Project: 720056: Iqaluit Water Treatment Plant – Fuel Tank Replacement	
RFT No.: 2023-RFT-057	
Addendum No. 01	No. of Pages: 2
Date: March 13, 2023	Doc. No.: P7201-1189411283-53(1.0)

The following change(s) in the Request for Tender Documents No. 2023-RFT-057 are effective immediately.

DRAWING NUMBER: P01

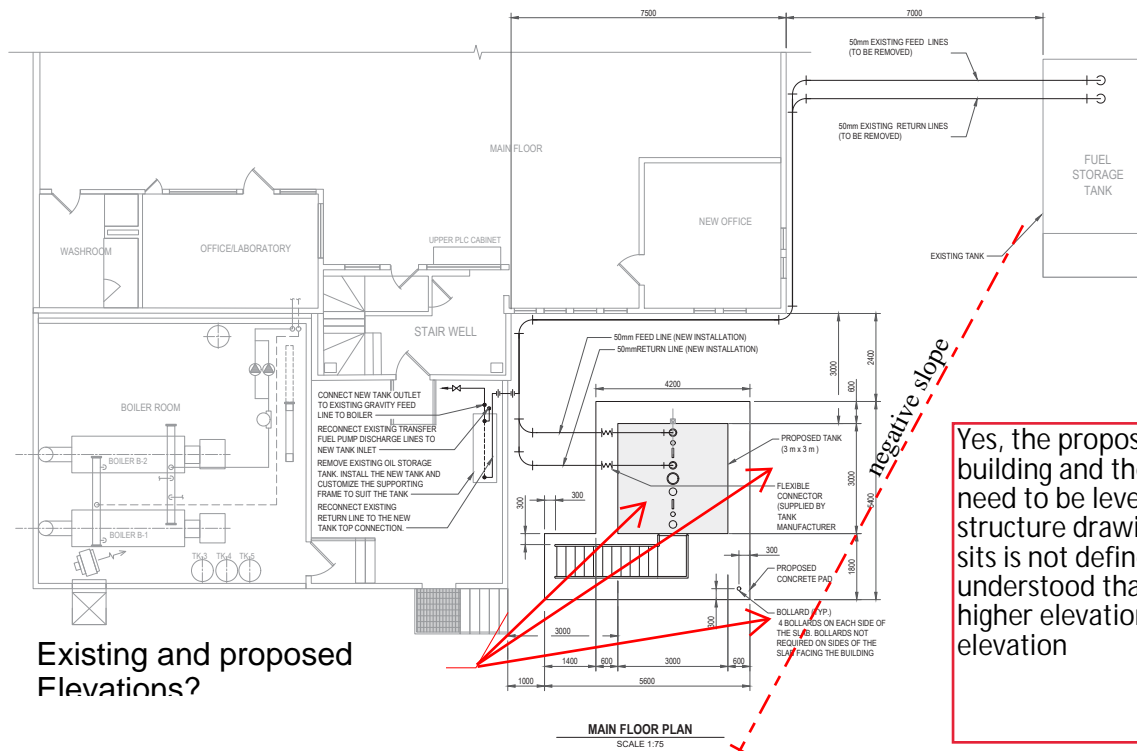
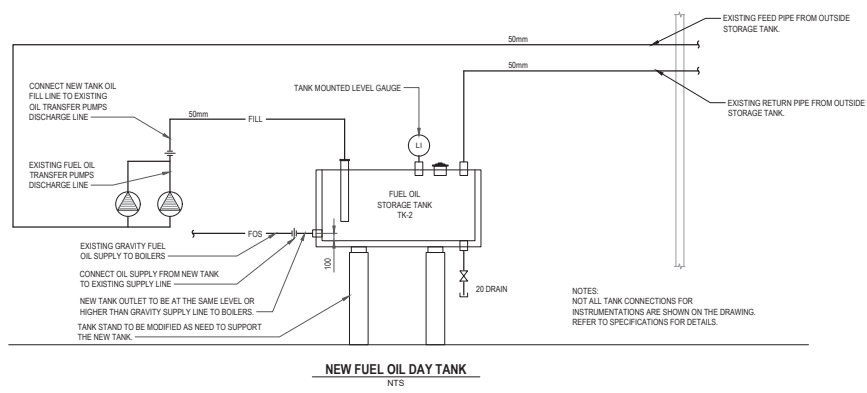
Can WSP provide the final elevations of the concrete slab, along with the existing elevations of the ground. This information is essential in light of the fact that there is a road leading through this area, which is on a downslope. Please refer to the attached dwg P01, which contains markups that will help further illustrate our request.

Existing and proposed Elevations?

Enclosed

Yes, the proposed tank is on a slope towards the building and the areas where the concrete pad, will need to be levelled up and compacted as per the structure drawing. The ground level where the pad sits is not defined as it is not critical and it is understood that the existing fuel tank is at a much higher elevation but not trying to match any elevation
